DATE: April 12, 2019
TO: Rideau Valley Conservation Authority
ATTENTION: Hal Stimson, RVCA Inspector
SUBJECT: Barrhaven Conservancy
Jock River Floodplain – Cut/Fill Analysis – REVISED

This analysis has been prepared to support development of Barrhaven Conservancy, Phase 1 and is a **proposed minor revision** to the previously approved cut/fill permit **RV5-17/18T issued September 26, 2018** (attached for ease of reference).

PROJECT No.:	16-891
SCALE:	1:3000
DATE:	APRIL 11, 2019
FIGURE:	1

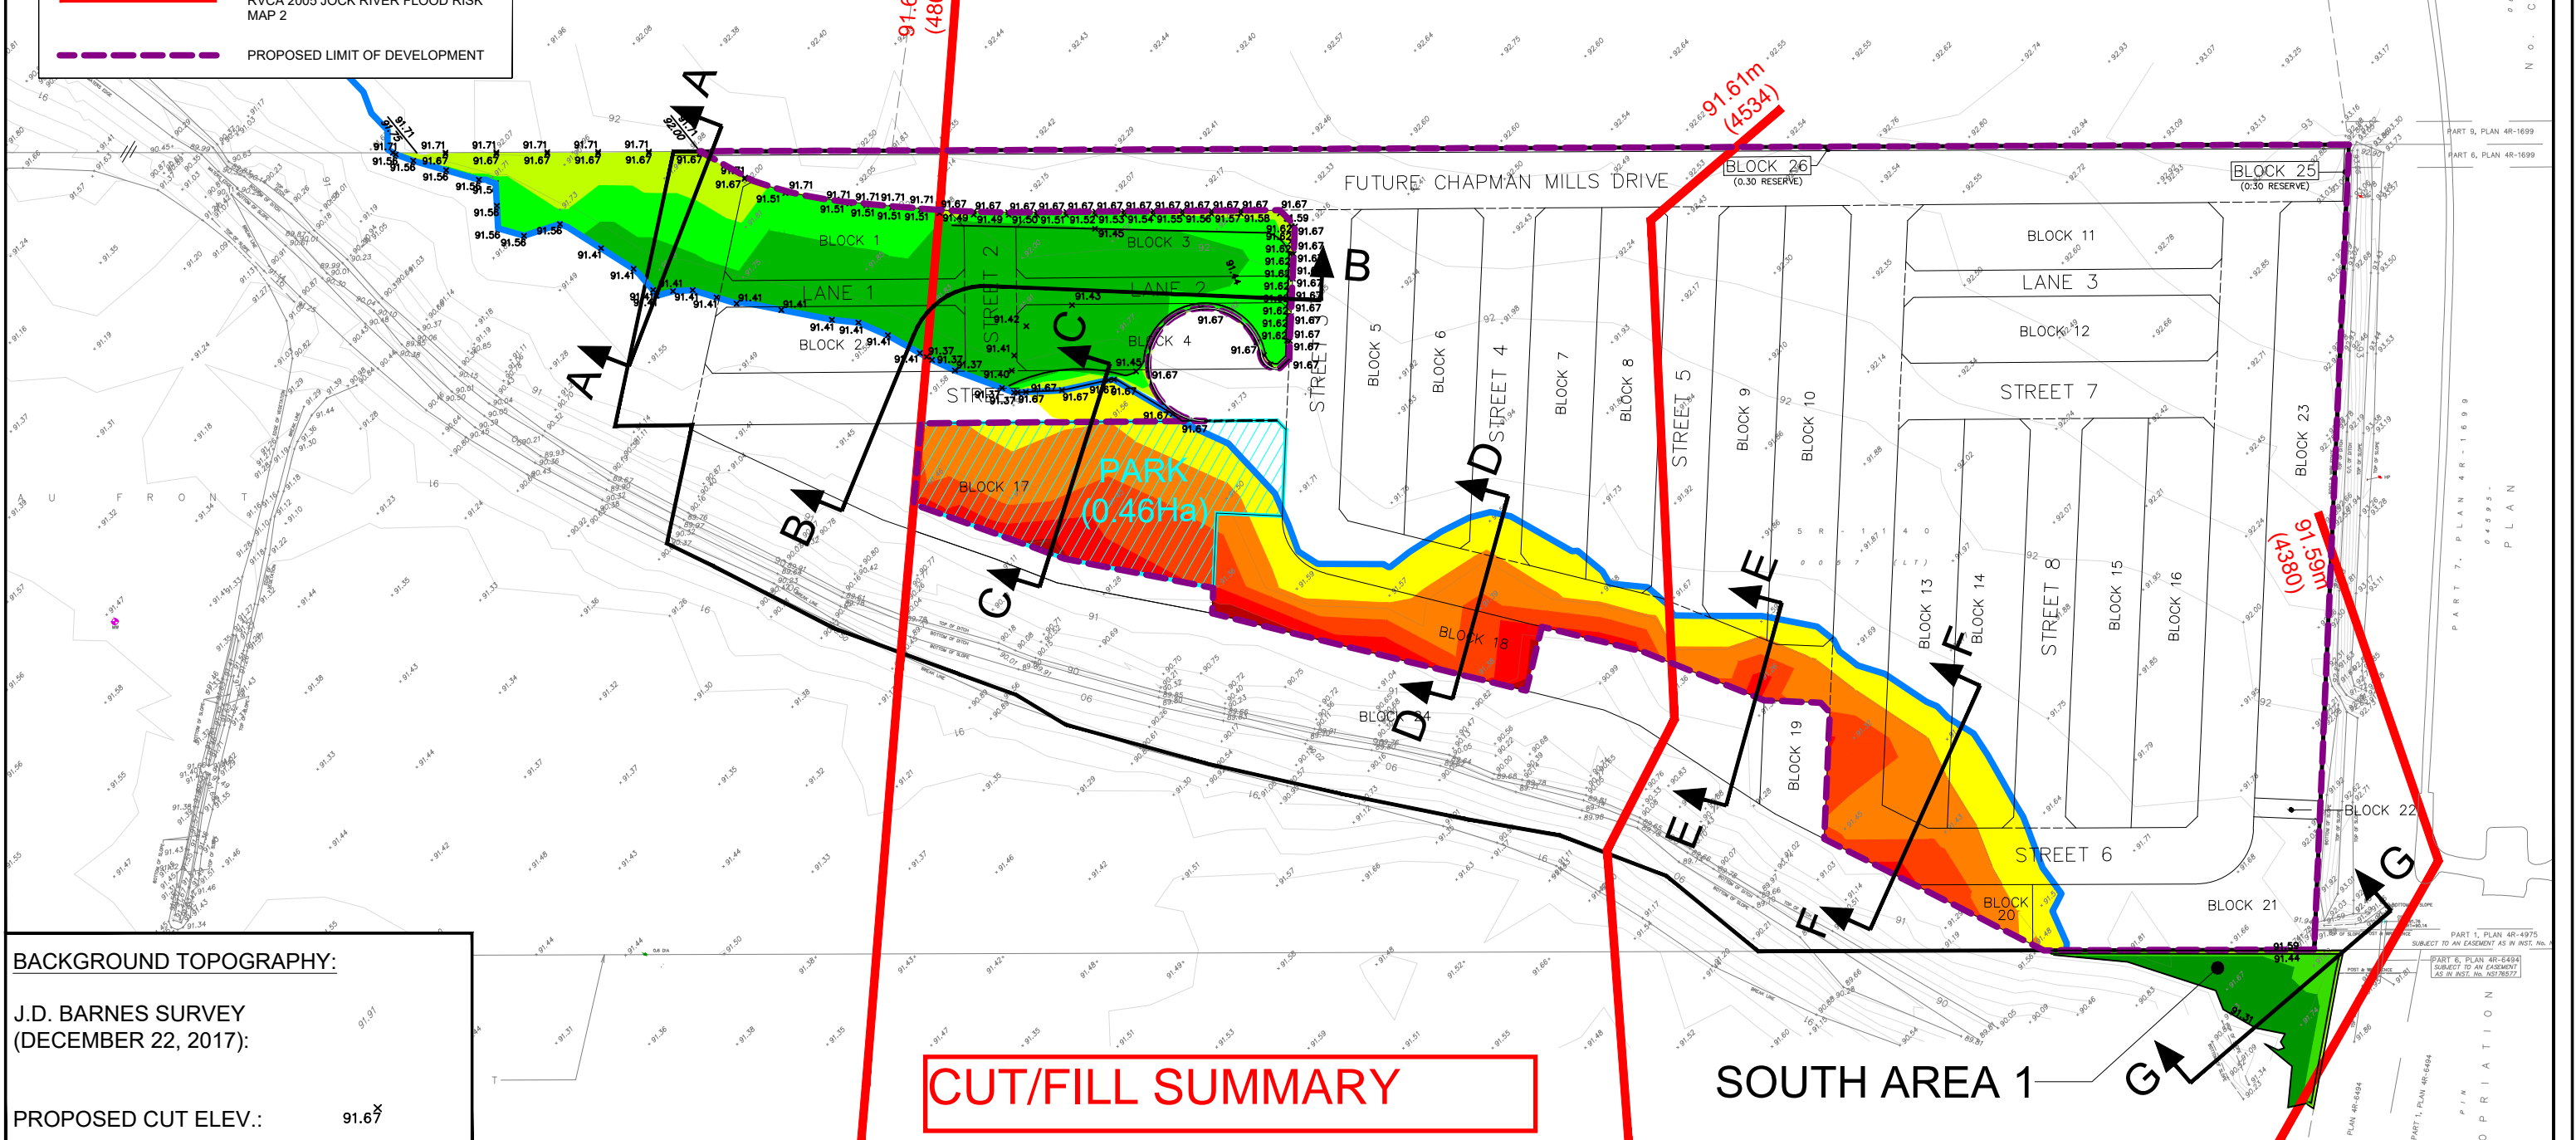
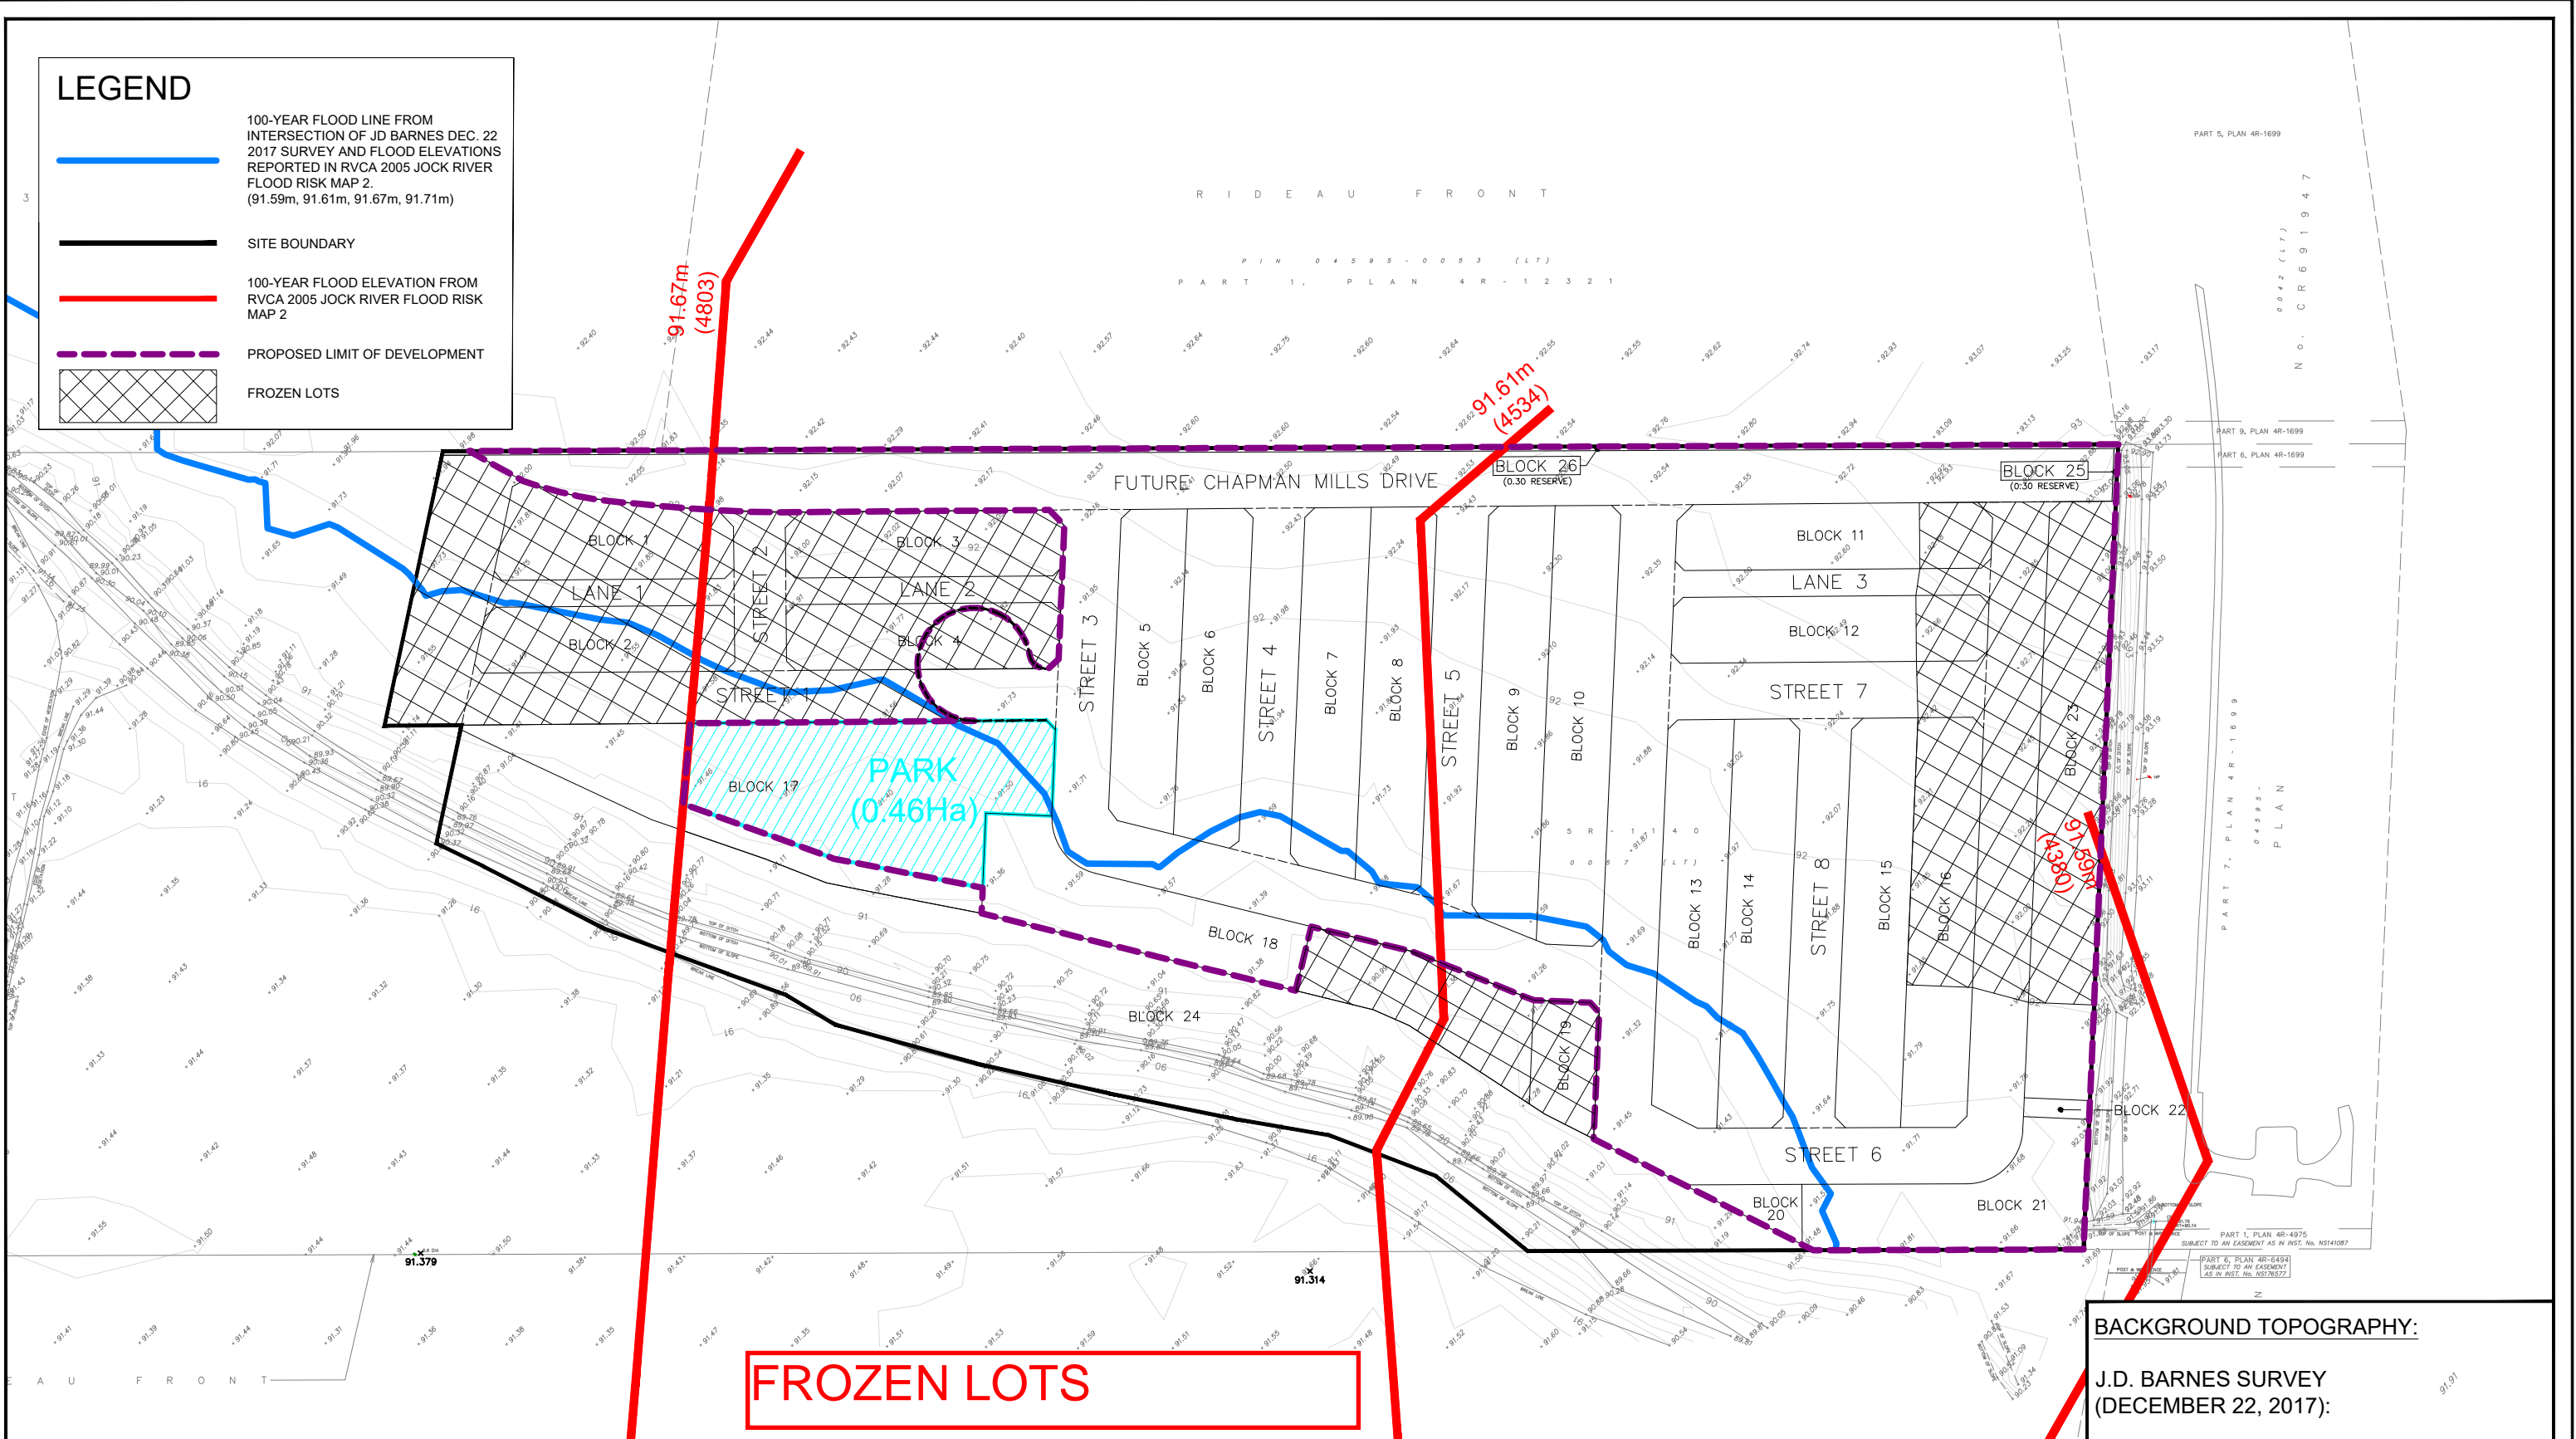
The attached updated figure illustrates the existing and proposed topographic conditions encountered on site as they relate to the 2005 Jock River Flood Risk Map 100-year regulatory flood elevations (cross sections 4380 + 4534 + 4803 + 5002). Existing topographic conditions are based on J.D. Barnes survey (December 22, 2017). Proposed topographic conditions are based on the Barrhaven Conservancy Phase 1 Draft Plan (dated July 27, 2018) and DSEL's proposed grading along the Regulatory Flood Limit.

- 1) The line of intersection of the 100-year Flood Limit Elevation and Existing Topography within the property. The line created at this intersection is considered to represent the Regulatory Flood Limit.
- 2) The proposed floodplain infill via the calculated volume between the surfaces created by i) the 100-year Regulatory Flood Limit Elevation and ii) J.D. Barnes topographic survey (December 22, 2017) within the development areas within the Regulatory Flood Limit. The 100-year water level is between 91.59 m and 91.67 m per RVCA 2005 Jock River Flood Risk Map. The total fill proposed below the 100-year water level elevation is 2,260 m³.
- 3) The proposed cut areas that were identified by comparing the surfaces created by i) the proposed draft plan (Barrhaven Conservancy Phase 1, July 27, 2018) and DSEL's proposed

grading, and ii) the 100-year Regulatory Flood Limit Elevation. The proposed plan provides areas to cut below the 100-year Regulatory Flood Limit Elevation.

The proposed cut ties into the existing topography as surveyed by J.D. Barnes, December 22, 2017, and to the proposed subdivision. The proposed depth of cut does not exceed 0.30 m below the reported 100-year Regulatory Flood Limit Elevation, in accordance with RVCA regulatory policies (Section 2.1). The 100-year water level is between 91.61 m and 91.71 m per RVCA 2005 Jock River Flood Risk Map. As demonstrated in Figure 1, the total cut proposed under the 100-year Regulatory Flood Limit Elevation is 2,290m³ (312+1,978) which is 30 m³ greater than the proposed 2,260 m³ fill within the floodplain.

This proposed fill is considered consistent with the intent of the RVCA policy. As demonstrated in **Table 1**, the cut volume is greater than the fill volume at every stage of the analysis, up to 0.3 m below the 100-Year Flood Limit Elevation. The total compensating cut volume exceeds the total fill volume.
